UNITED STATES ENVIRONMENTAL PROTECTION AGENCY
WASHINGTON, D.C. 20460

WASTE CHARACTERIZATION TIER 1 CHANGE REPORT
EPA TIER 1 EVALUATION
OF THE CENTRAL CHARACTERIZATION PROGRAM
REMOTE-HANDLED TRANSURANIC WASTE CHARACTERIZATION PROGRAM
FOR THE SAVANNAH RIVER SITE:
ADDITION OF WASTE STREAM SR-RH-MNDPAD1.01

June 2016

Figure 1. Flow Diagram for the Radiological Characterization Process of Waste Stream SR-RH-MNDPAD1.01

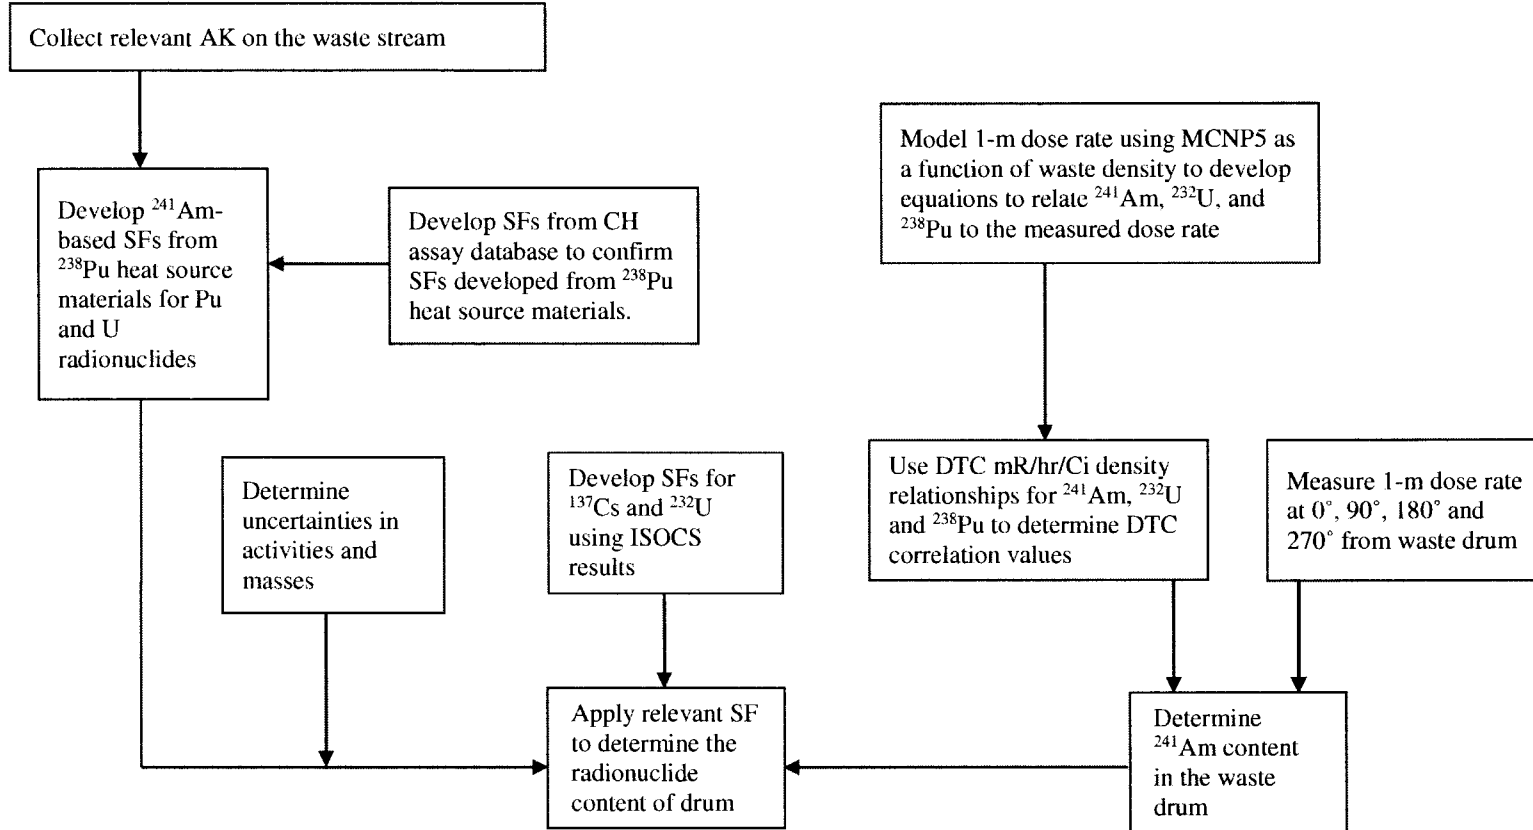
The overall approach to the radiological characterization of Waste Stream SR-RH-MNDPAD1.01 is the dose-to-curie (DTC) approach, with americium-241 (^{241}Am) as the key radionuclide. The EPA evaluation team prepared a flow diagram to reflect this process, shown in Figure 1. EPA determined that the radiological characterization process for Waste Stream SR-RH-MNDPAD1.01 was technically adequate and appropriately documented.
